Our Ref: 2021 – 011

RE: KAVANAGH OBJECTION to SSD-10394
ST JOHN OF GOD RICHMOND HOSPITAL REDEVELOPMENT
Lot 11 in DP 1134453, 235 Grose Vale Road, North Richmond

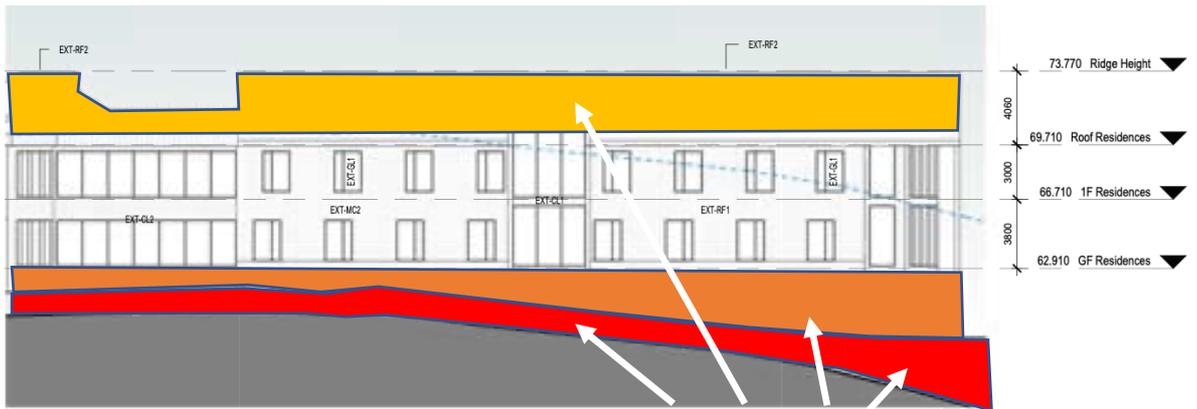
The Site Analysis image at Figure 3 of the Design Report is blurry. The RL of the closest current hospital building to our client's farm site is not legible. A similar blurry image is included as Figure 4 which has illegible RLs for proposed new buildings. The objection also incorrectly refers to FSR at one point, rather than height. The DA's '10m height boundary plan' confirms a proposed maximum roof height of RL 73.77 – but this plan does not include any details to confirm the actual ground level under that RL73.77 nor any details to confirm the height of basement/subfloor areas and any fill or retaining walls that are additionally proposed in any particular location on the site.

Additionally, no visual analysis of the proposal from the Kavanagh's property (which includes three dwellings) plus extensive other farm infrastructure, has been undertaken despite this forming a clear component of the Department's SEARS requirements.

07 SOUTH ELEVATION
SCALE: 1 : 200

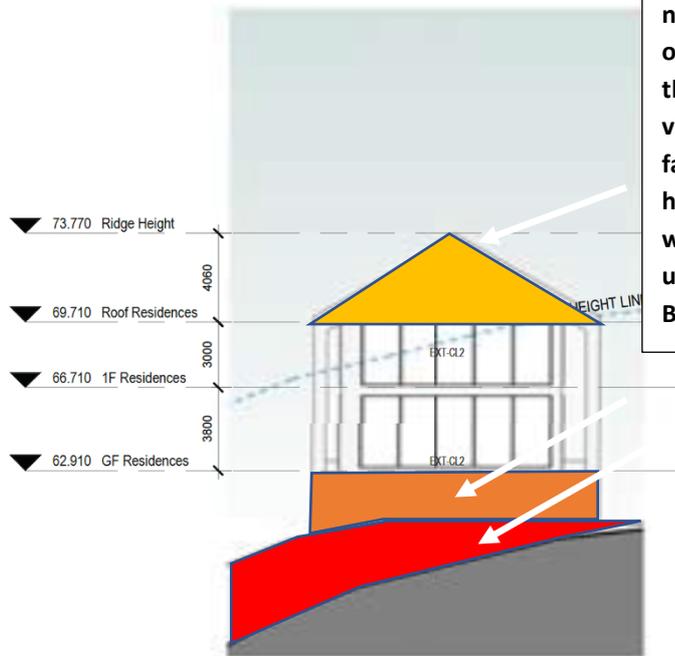
The non-complying southern elevation of the redevelopment will present as a domineering form from the Kavanagh’s property, due primarily to the proposed voluminous and high-pitched roof, combined with an elevated finished ground floor level for the four residential pavilions that will sit above natural ground level along a majority of the residential pavilion length.

Cross Sections 7 and 8 as extracted below illustrate how the proposed height non-compliance is a result of these few unreasonable design choices and which non-compliance could easily be rectified by setting the 4 pavilions at a lower natural ground level, reducing fill and/or subfloor areas and determining to adopt a lower pitched, skillion or relatively flat roof form.

Aspects of proposed hospital build that add significantly to the height non-compliance and overall bulk and scale of the proposal when viewed from adjacent farmland and the farm house and which height will also compete unnecessarily with the Belmont House roof line

A reasonable reduction to the proposed pitched roof coupled with a drop in the ground floor level through additional minor site excavation at the higher end of the pavilions and a reduction on subfloor area could be agreed in order to achieve full and/or more substantial compliance with the LEP height control. These are all relatively modest changes that can be achieved without impacting on proposed hospital bed numbers, preferred internal floor to ceiling levels or the preferred floor plan and disabled access outcomes.

3. **A reduced roof height and a reduced adopted ground level for all 4 of the residential pavilions is requested** – these pavilions being positioned along the southern edge of the hospital site and which are currently proposed to exceed the adopted height of buildings control by 3.4m.
